VALUE ENGINEERING STUDY

Project # IMNH0-0285-01(352) PI No. 713300-

I-285 at Bouldercrest Road Interchange
DeKalb County, Georgia

23 February 2012

PROPOSAL NUMBER: R-3.0

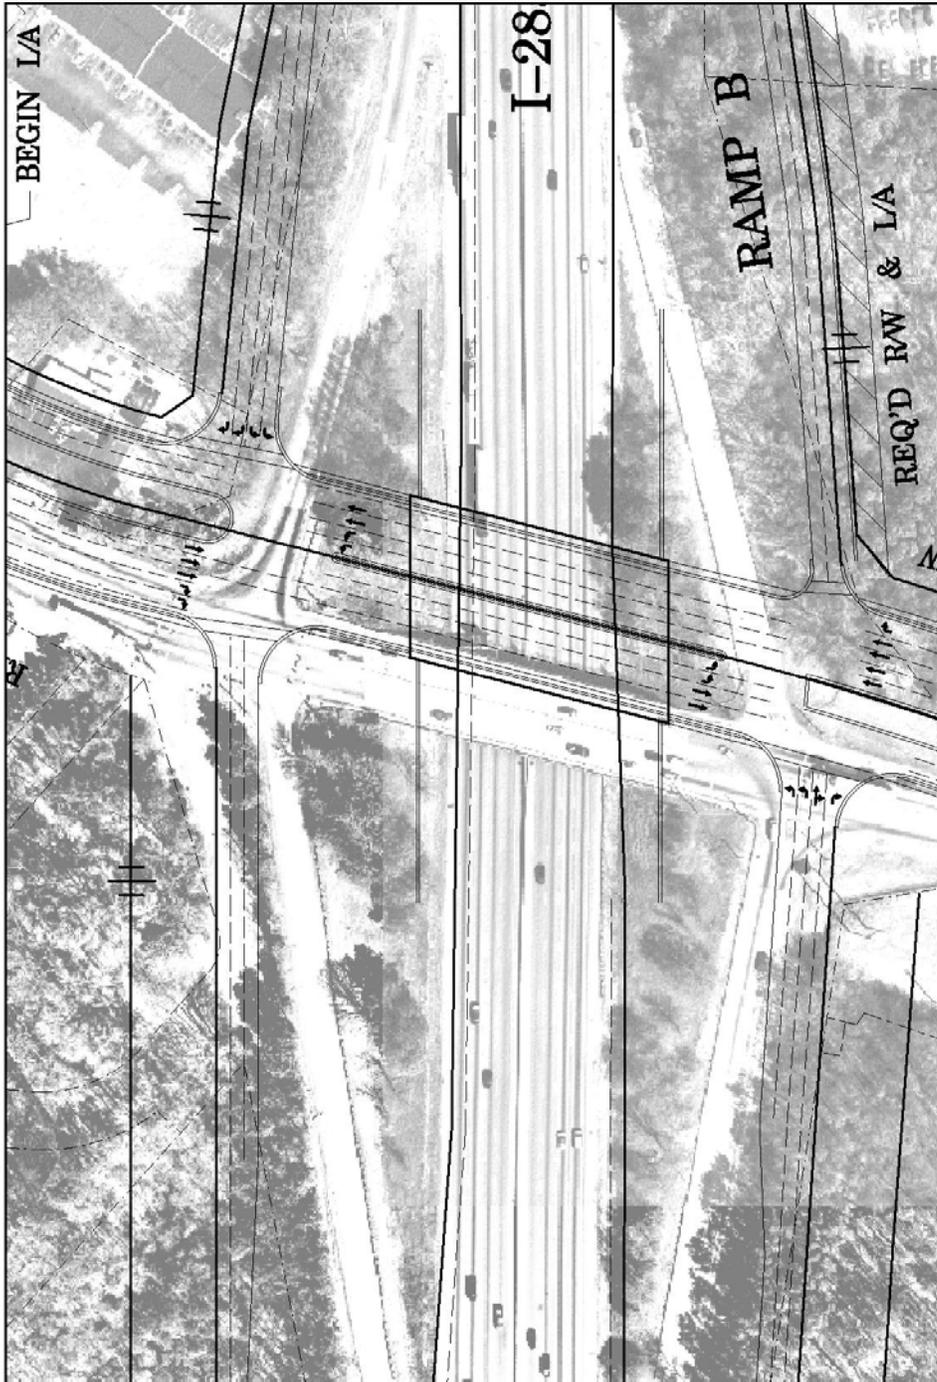
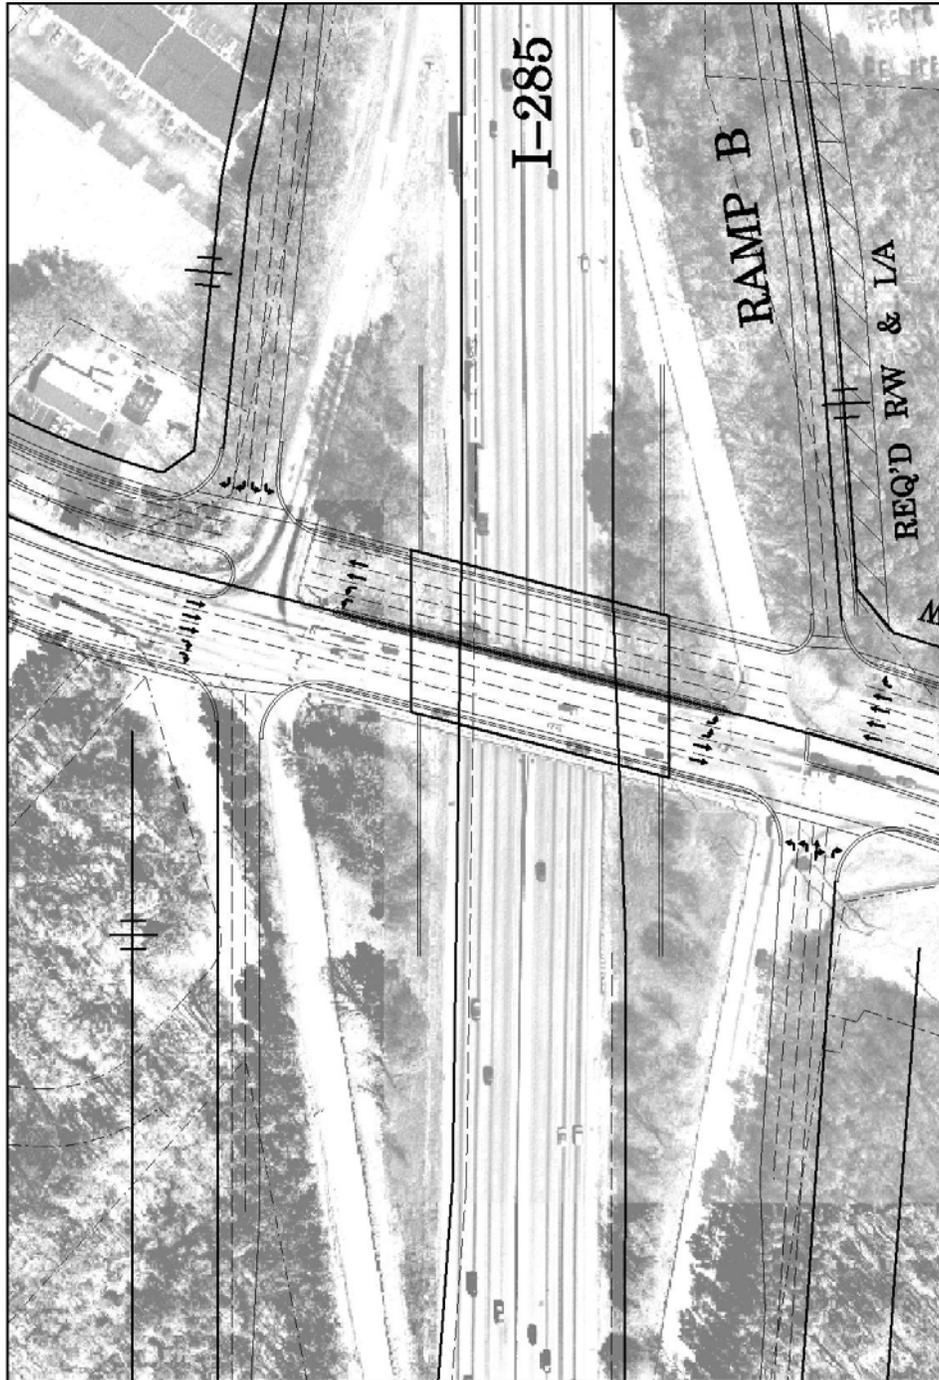
PROPOSED CHANGE: Stage construction will be utilized by constructing the Northbound side of the Bouldercrest Road bridge over I-285 first while maintaining traffic on the existing bridge; then shifting traffic to the new structure while demolishing the existing bridge. The new southbound side will then be constructed and final traffic configuration provided. Existing traffic on Bouldercrest Road will be maintained on existing roadway throughout with minor widening in the transition area. Approach roadway to the bridge over I-285 will be widened to provide a transition from the existing four-lane section to the eight-lane section (four through lanes and four left turn lanes) on the new bridge. Bouldercrest widening South of the new bridge will be lessened by retaining the existing roadway as the new Southbound side; Northbound will be reconstructed as planned to accommodate I-285 entrance ramp realignment.

PROPOSAL NUMBER: R-4.0

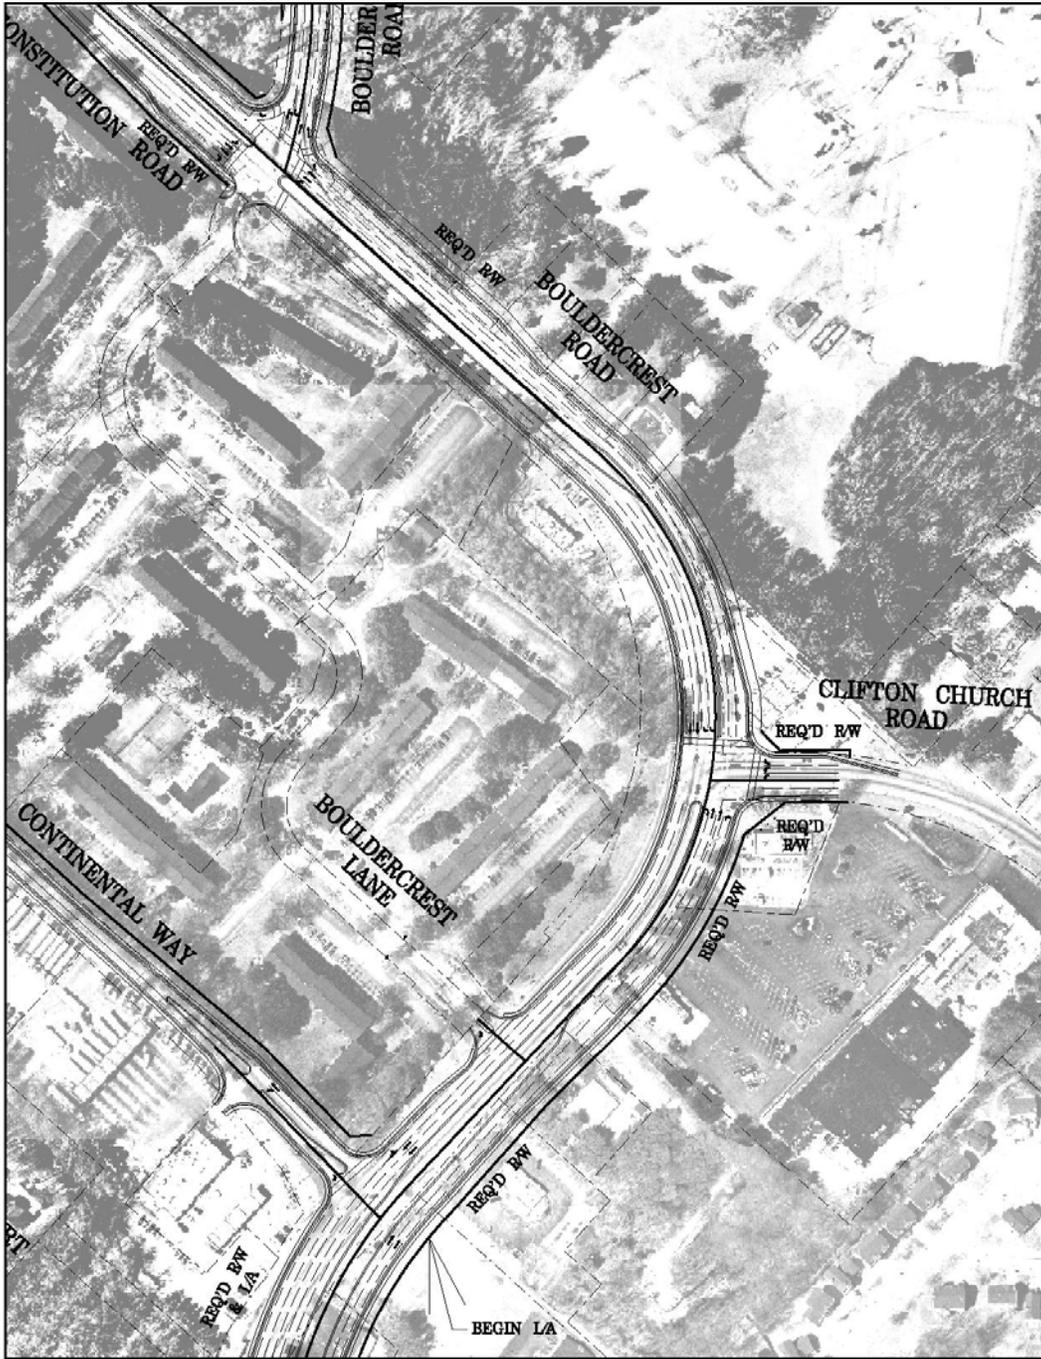
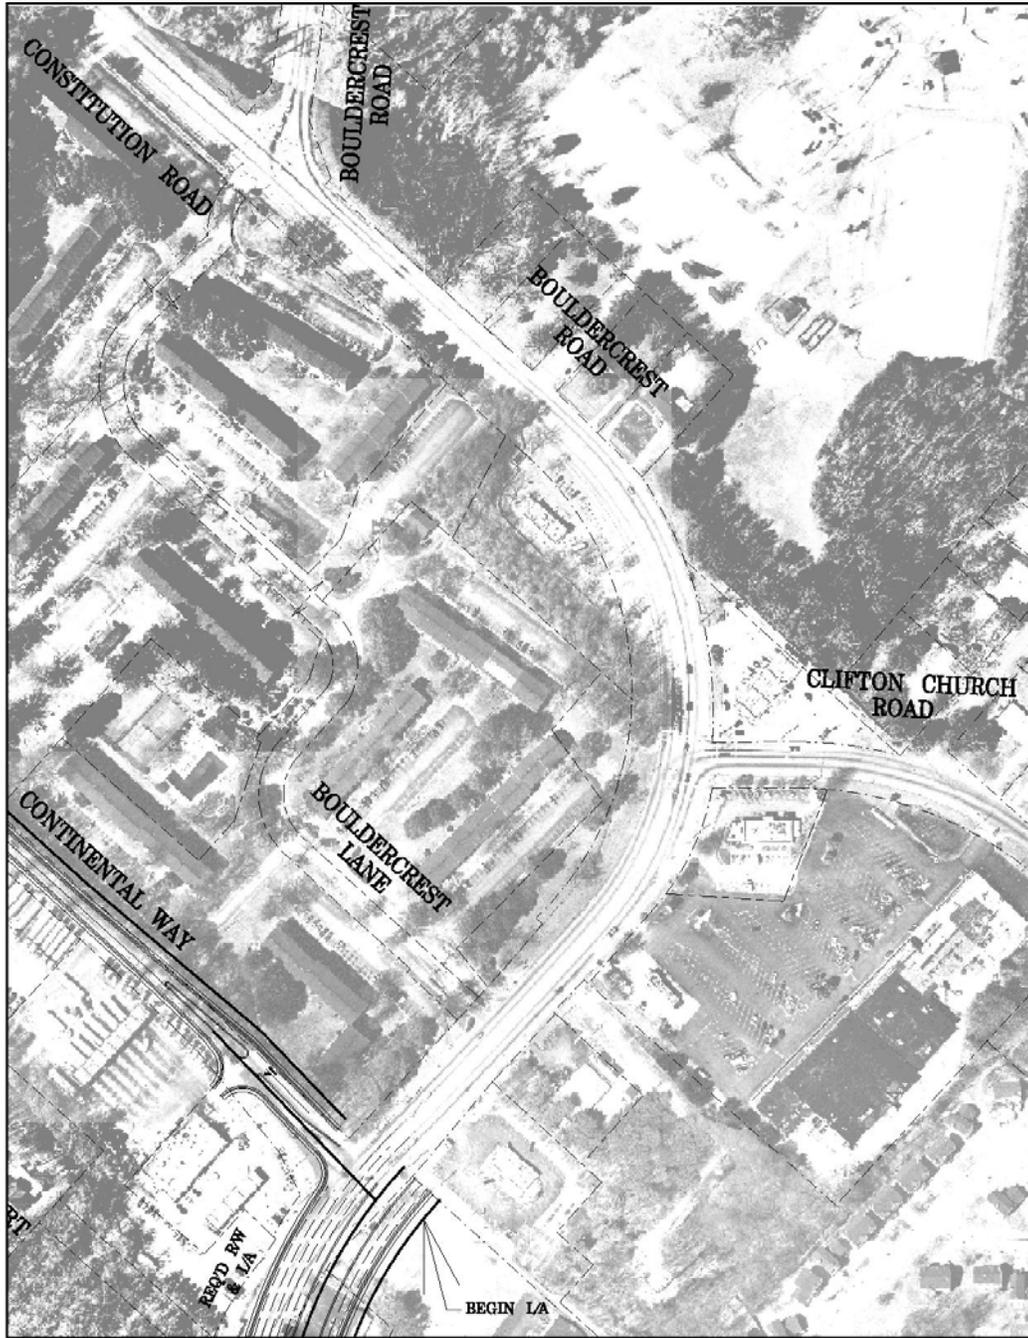
ORIGINAL DESIGN: The current design which includes the new bridge offset to the East requires realignment of Bouldercrest Road to the East to provide the same number of lanes and change degree of curve at Clifton Church Road intersection area.

PROPOSED CHANGE: It is proposed to eliminate realignment of Bouldercrest North of Continental Way. Keep existing alignment of Bouldercrest Road in this area. This proposal works in conjunction with Proposal 3.0 which shifts the new bridge to the West and thus would not require realignment of Bouldercrest in these areas.

PROPOSAL NUMBER: R-6.0

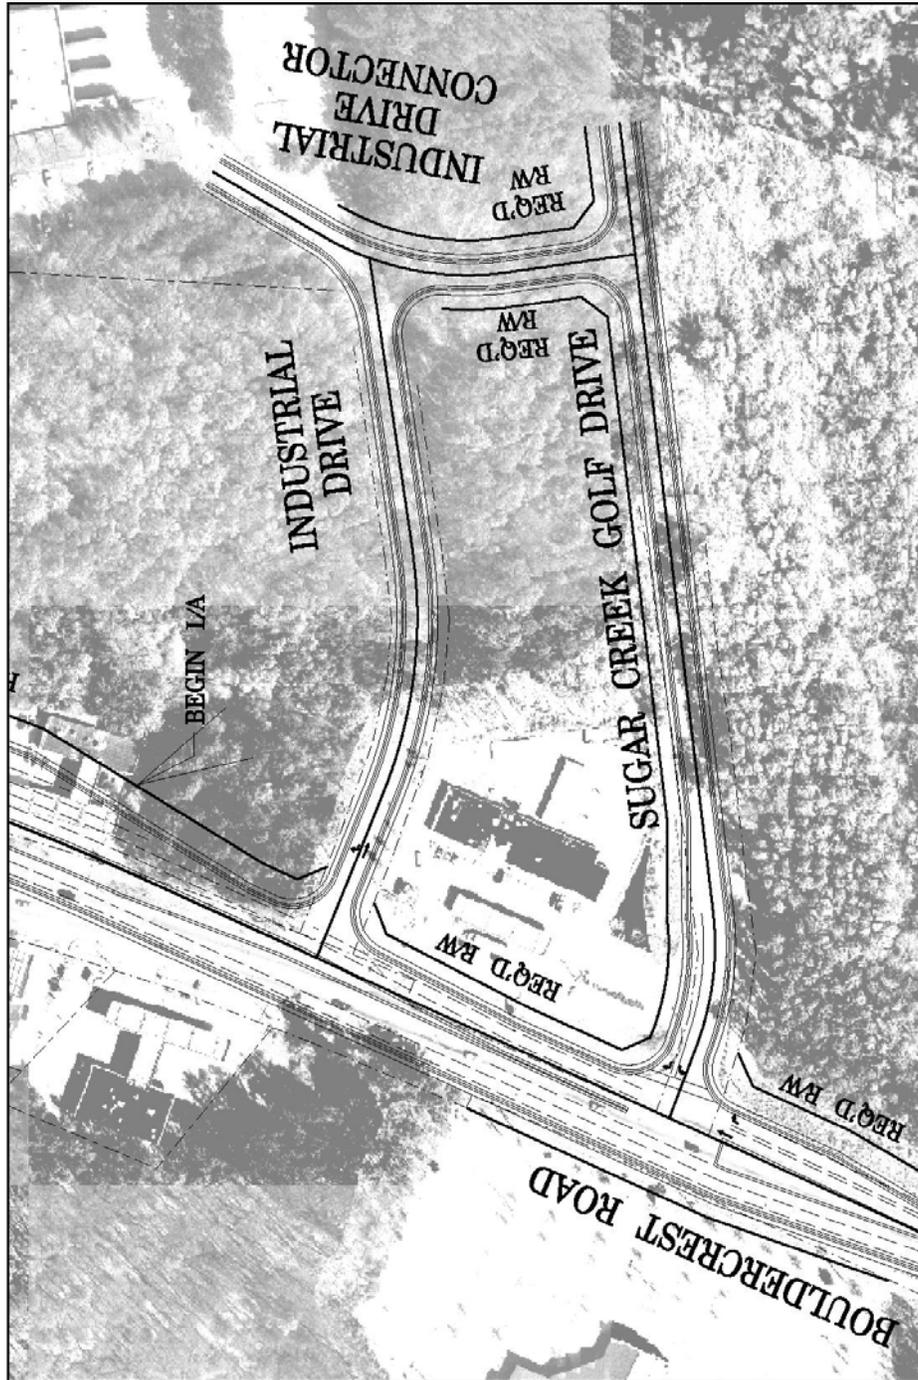
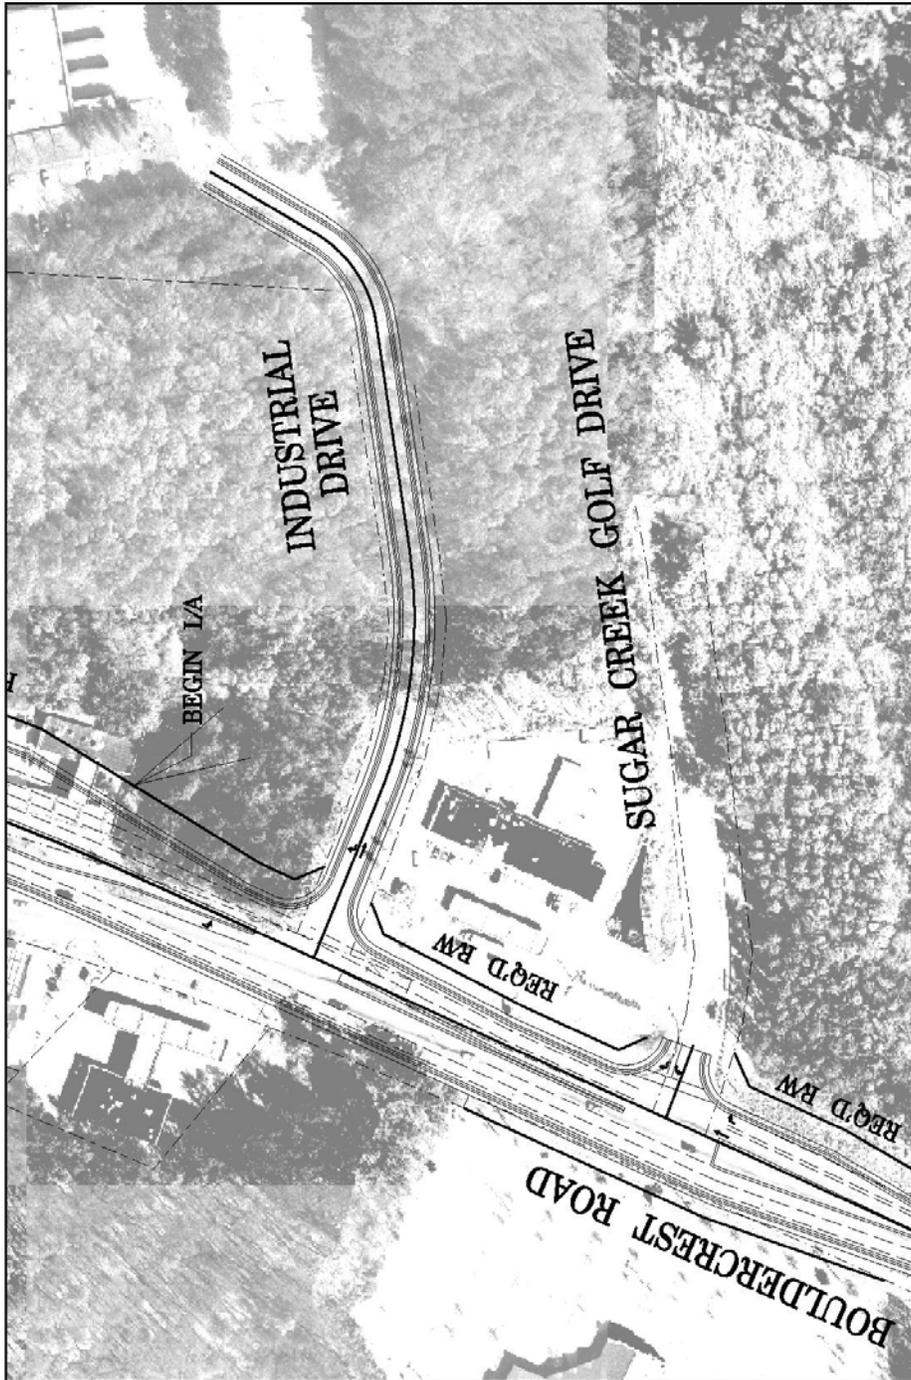
PROPOSED CHANGE: It is proposed to incorporate a dedicated left turn lane on Bouldercrest Road Southbound at Industrial Drive and eliminate both reconstruction of Sugar Creek Golf Drive and the new connector road.

JUSTIFICATION: Based on the total design hourly volume of the new Sugar Creek Drive entrance being only 40 vehicles per hour from the interstate (which would include the vehicles utilizing it both for access to Industrial Drive and the Golf Course), this low volume should not cause back-up of traffic into the off-ramp intersection. Thus, the left turn to Industrial Drive could be incorporated and would not require the currently planned improvements to Sugar Creek Golf Drive and construction of the connector. This alternative provides access to parcels along Industrial Drive and reduces both R/W impacts South of Industrial Drive and traffic impacts to Sugar Creek Golf Drive.

PROPOSAL NUMBER: R-7.0

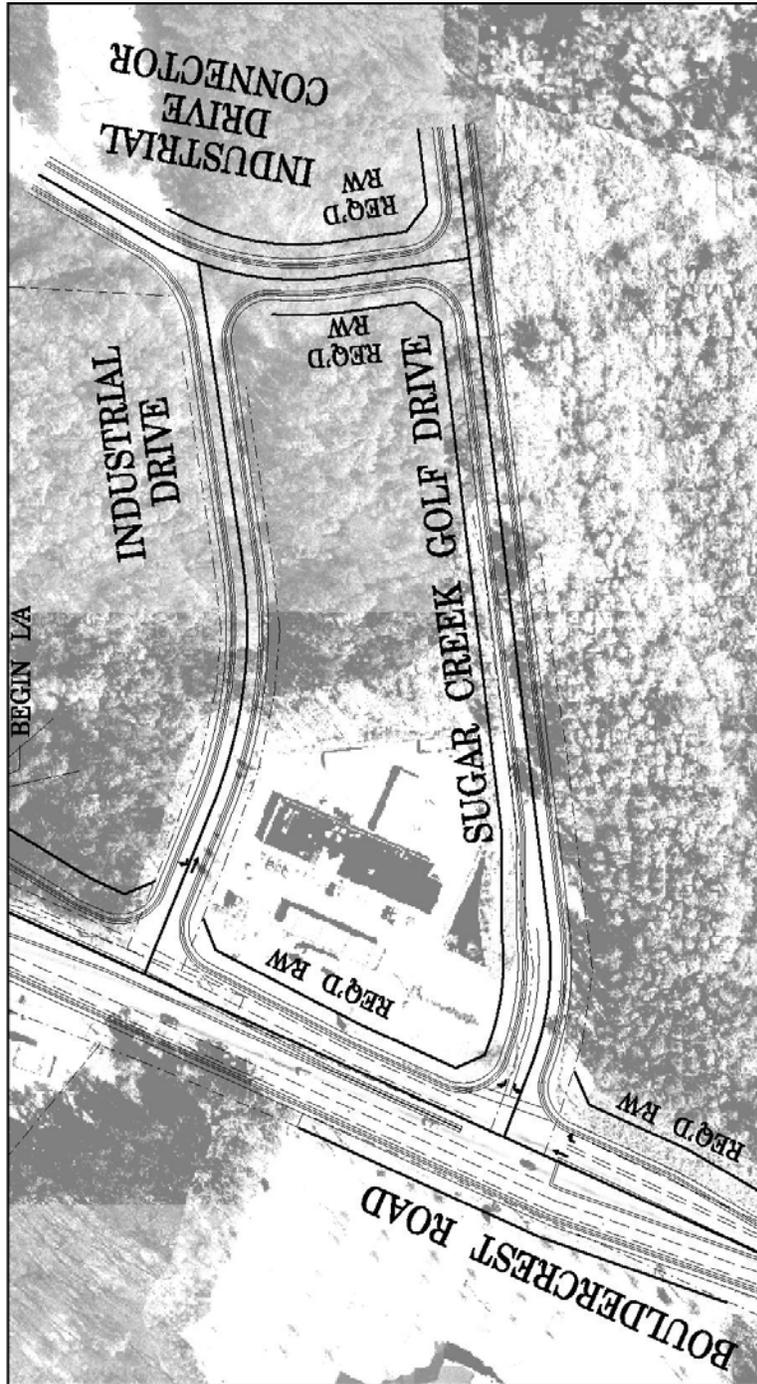
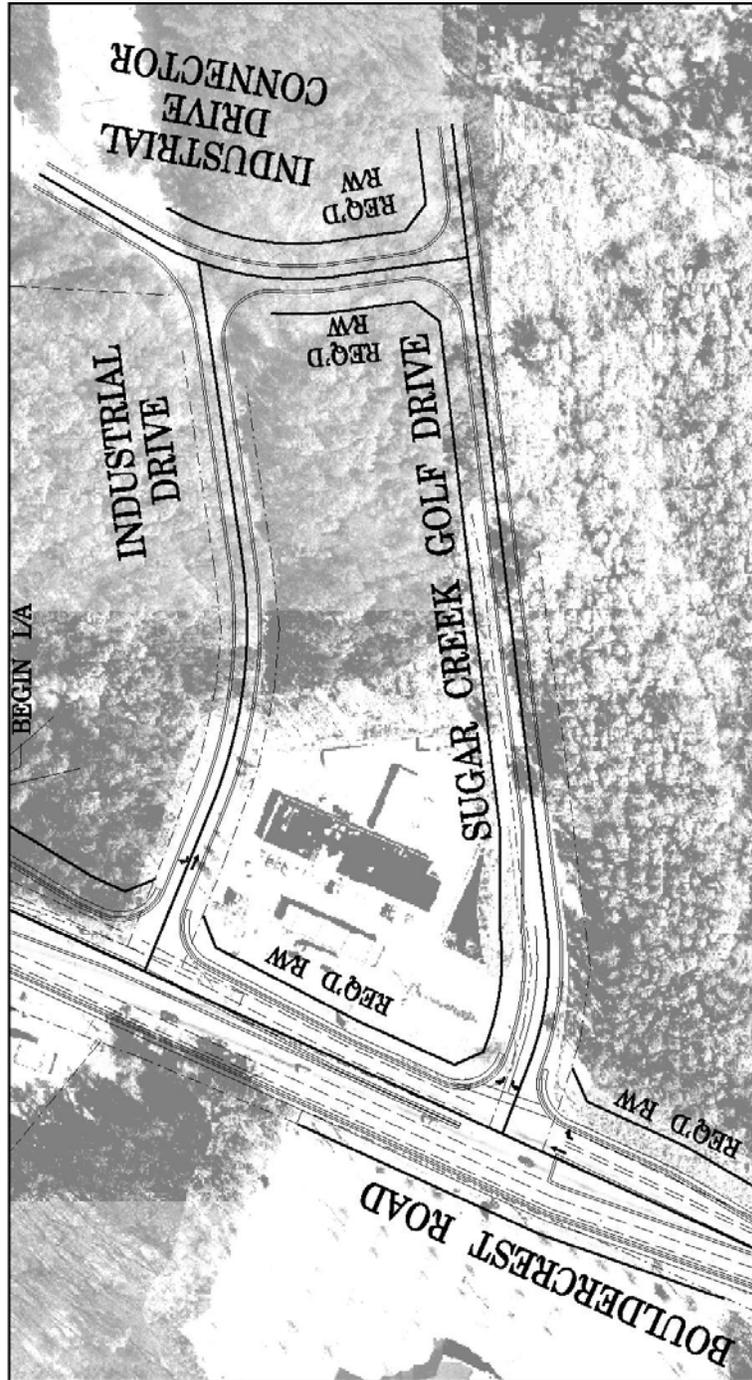
PROPOSED CHANGE: It is proposed to eliminate sidewalks from the improvements along Industrial Drive and Sugar Creek Golf Drive.
